Discharge Permit, Water Permit and  
Landuse Consent Application  
RM20.024

Oceana Gold Limited

**STATEMENT OF EVIDENCE OF JAMES MITCHELL BLYTH**

**14 July 2020**

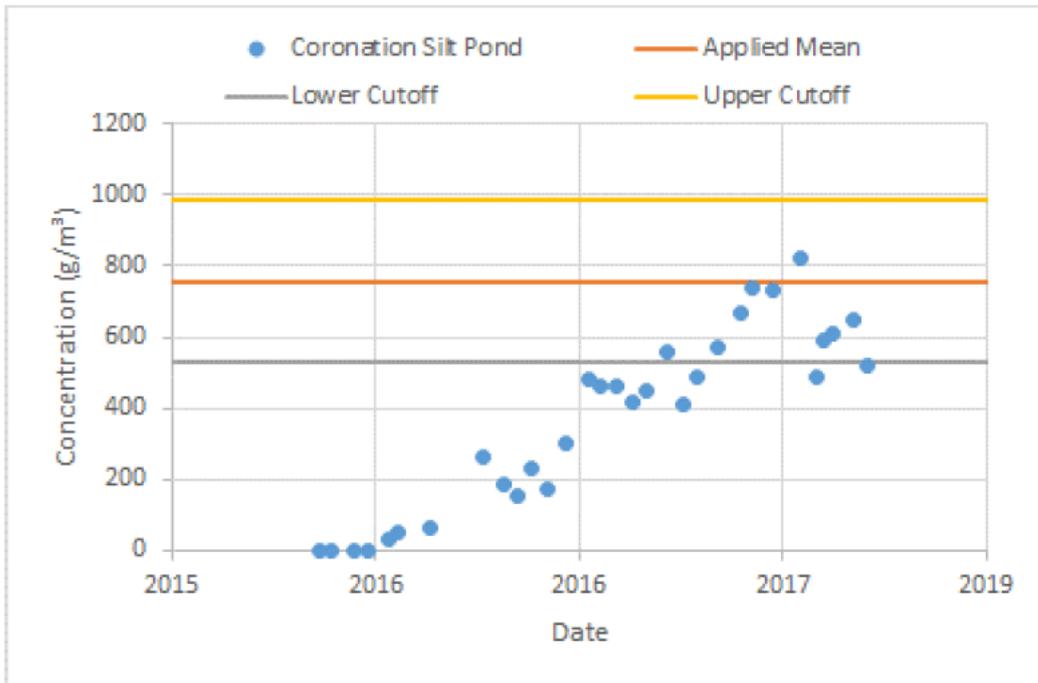
- However, concentrations at some locations are increasing (Figure 1) and may exceed the upper threshold applied in modelling, in the future. The lower flows simulated in the model (see evidence line 22) could provide conservative estimates of concentrations, however this is on the basis that the simulated seepage and runoff volumes from the waste rock stack would be accurate and contributing the appropriate load.

27 Assuming the truncated normal distribution method applied on other water quality parameters captures the observed data, as per the sulphate examples in the **S.92 Response**, this would be considered acceptable, however any sites that show an increasing trend in concentrations should be monitored (see Figure 1 below). As mentioned in evidence line 26, no model input data was provided by the applicant for these other parameters and I have therefore not assessed their suitability.

28 The current upper threshold for sulphate in Figure 1 has been applied in the model and exceeds the highest recorded observed concentration by ~20%, providing margin for the water quality modelling. See **RECOMMENDATIONS** section at the end of this evidence for consideration of additional monitoring.

- 34 Ongoing water quality monitoring within the mine site is recommended at existing sites used to provide water quality inputs within the GoldSim model, and additionally at locations downstream of planned developments (such as waste rock stack seepage or any spoil piles), should the consent be granted. In my opinion, an additional 3–5 years of observed data would help validate the models input assumptions.

Figure 2. Comparison of measured and modelled nitrate-nitrogen concentrations at Shag River at Loop Road from 2015 to 2018 (this is reproduced from Figure 3-14 in the **S.92 Response, Appendix E - GHD Response to ORC RFI**).

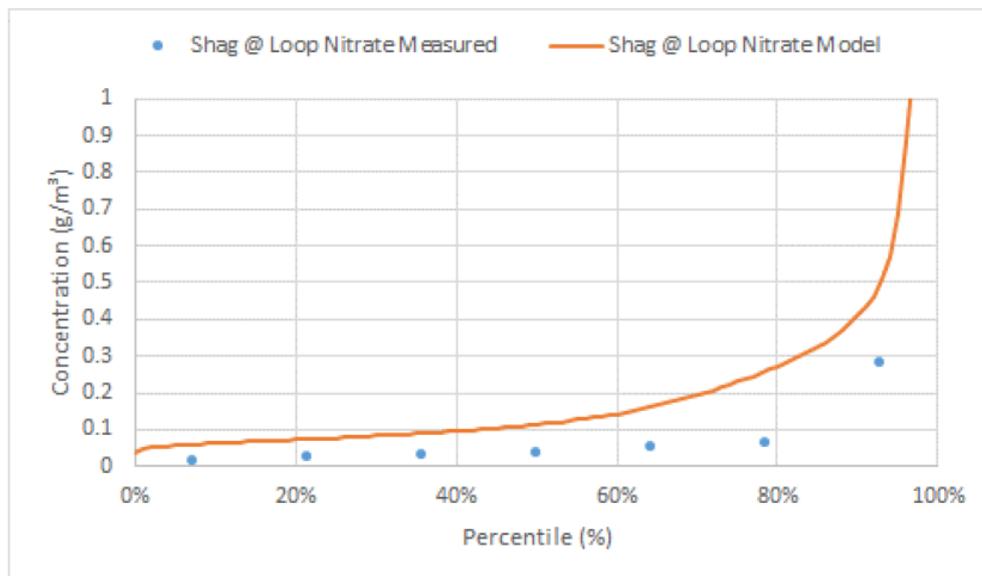
- In regards to nitrate-nitrogen concentrations, a background value (greater than the mean concentration) of 0.05 g/m<sup>3</sup> was applied in the model. This was from a very limited dataset of only four data points prior to 2015, and may not represent the full range of river concentrations, which can fluctuate significantly over a year depending on upstream farming practices and seasonal hydrological changes. The 'natural' background nitrate-nitrogen load could be higher and subsequently, any modelled impacts of the mine (contributing to a nitrate-nitrogen load) may underestimate the cumulative effects in the receiving environment (i.e. the Shag River).

- 31 The **S.92 Response** presents the water quality model calibration from 2015-2018 for sulphate and nitrate nitrogen at DC08 and Shag River at Loop Road. This compares modelled concentrations against observed water quality data and showed the baseline model is suitably calibrated for scenario assessments of the waste rock stack development and would be considered conservative when simulating sulphate concentrations. Limited monitoring data for nitrate-nitrogen data (see Figure 2) reduces the confidence in the models baseline calibration for this contaminant, despite the model showing it is conservative in simulating nitrate-nitrogen concentrations. Only 12 sample concentrations are presented over a 3 year period for DC08 and 7 samples at Loop Road.

- 35 Further monthly/bi-monthly monitoring of the nitrate-nitrogen concentrations is recommended at DC01 and/or DC08 to validate the natural background nitrate-nitrogen concentrations and the fixed value of 0.05 g/m<sup>3</sup> applied in modelling.
